Project: IEEE P802.15 Working Group for Wireless Personal Area Networks (WPANs)

Submission Title: [Preamble Comments Resolution]

Abstract: [SC & HSI preambles resolution]

Purpose: [Solve comments related to SC & HSI preambles]

HSI MCS0

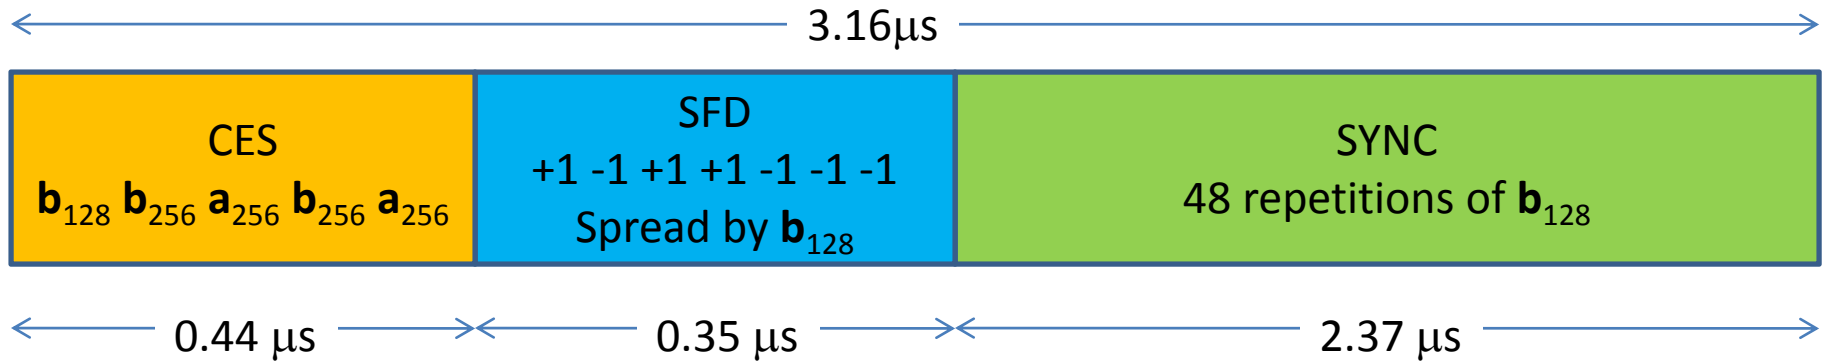
- Total duration
- Sample rate is unchanged: 2592 MHz

CMS Header (No change)

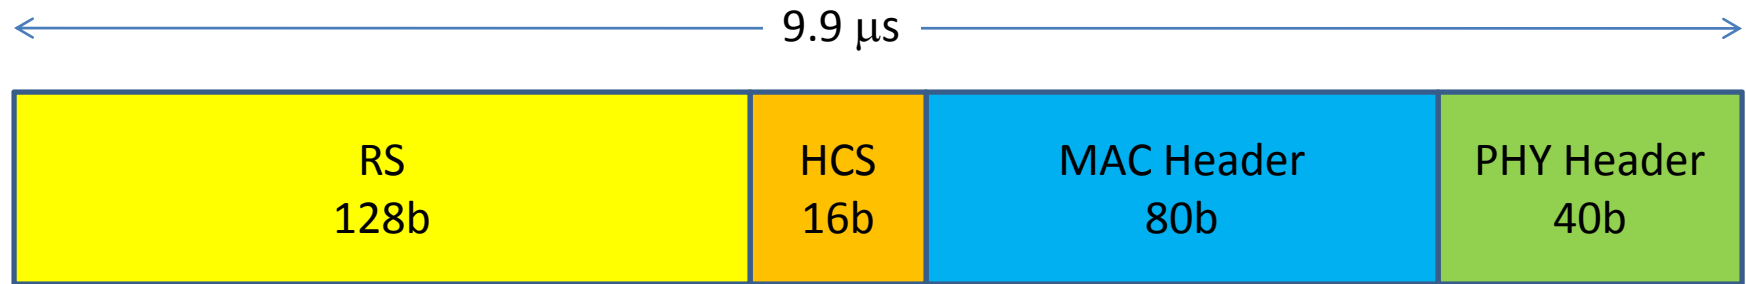
- CMS header is too long to be used for HR data packets in CAP.
- If we were to use CMS preamble for all transmissions in CAP than it is better to define an extra field (we are not adopting this):
 - Duration 8b (in μs)
 - Header mode 2b (00 ⇔ CMS, 01 ⇔ MR, 10 ⇔ HR),
 - CRC 1 bit
 - Encoding Ham(15,11)
 - Spreading with \mathbf{a}_{64}

High Data Rate Preamble (SC & HSI)

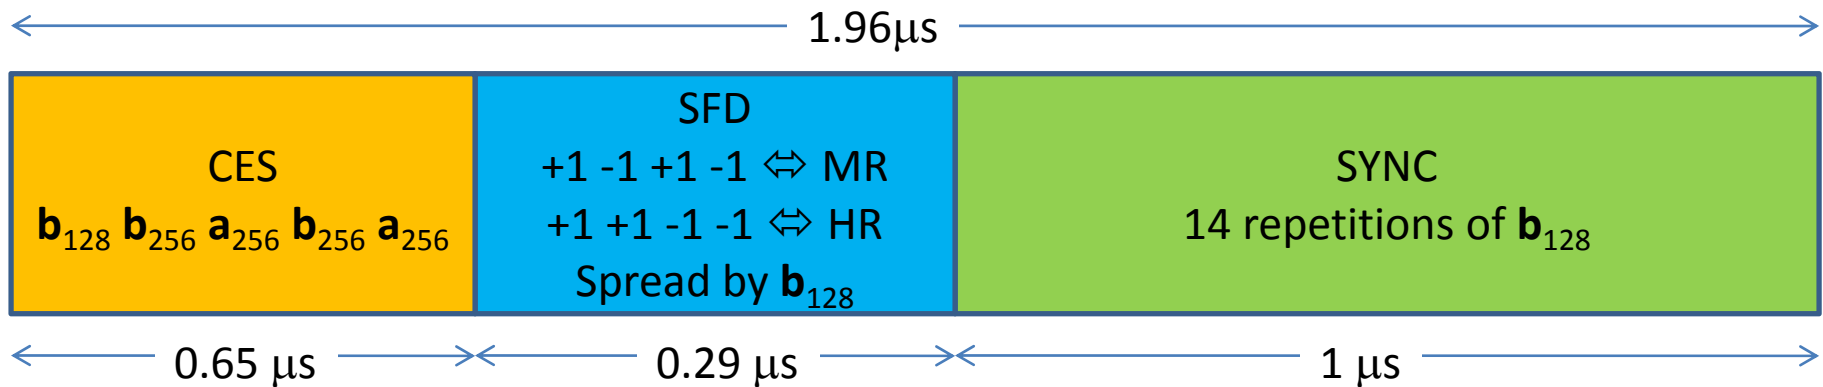
- SFD = $[+1 -1 +1 -1]$ (-1 first in time) means MR (medium rate) header
- SFD = $[+1 +1 -1 -1]$ (-1 first in time) means HR (high rate) header
- Durations shown are for SC (not HSI)

Sub-block with $PW = 8$

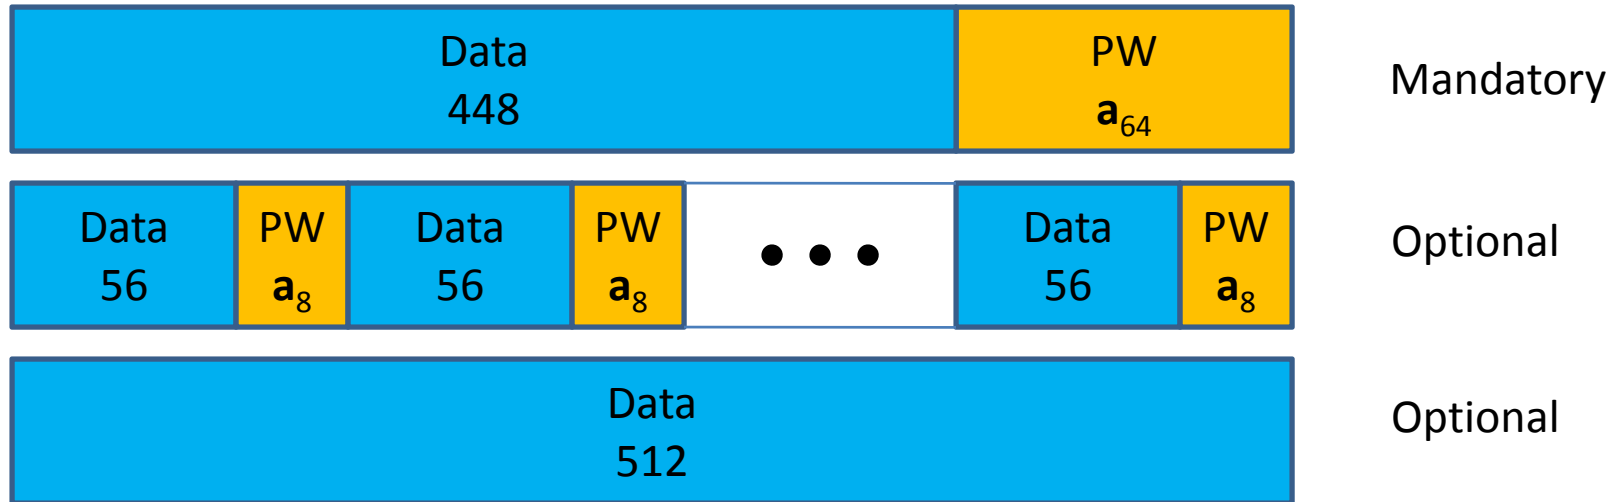
- The first 2 options have the same data rate
 - Option 1 is for long delay spread
 - Option 2 is for low power near-LOS
 - Option 3 is for pure LOS
 - 2 bits in the PHY header to indicate the modes
 - Receive status field should be 2 bits
 - Add it as well to capability IE

SC High Rate Header

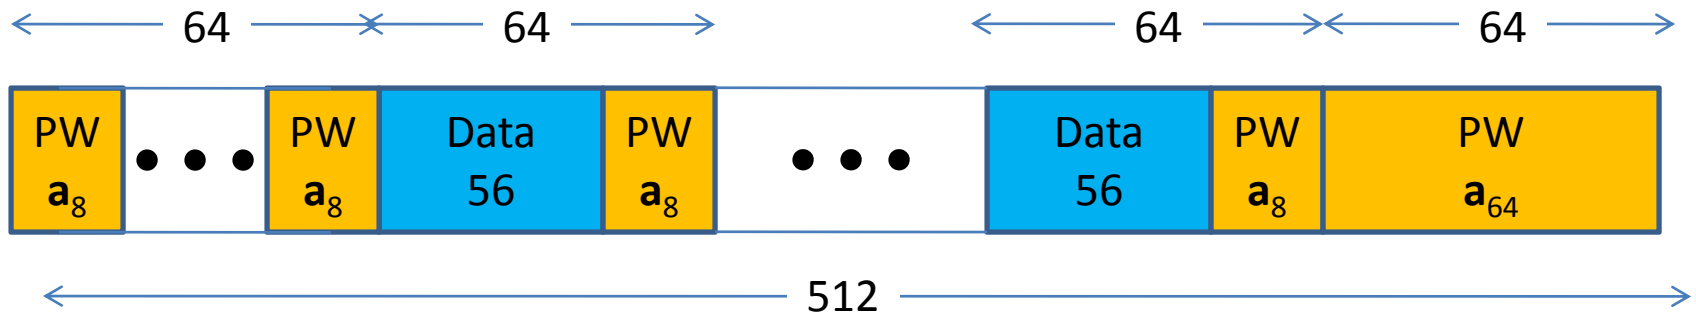
- MR (Medium Rate) header
 - Spreading factor = 6
 - Number of occupied sub-blocks = 5
 - Number of stuff bits = 16 bits (96 chips)
 - Header rate = 181.5 Mbps
- HR (High Rate) header
 - Spreading factor = 2
 - Number of occupied sub-blocks = 2
 - Number of stuff bits = 72 bits (144 chips)
 - Header rate = 453.75 Mbps
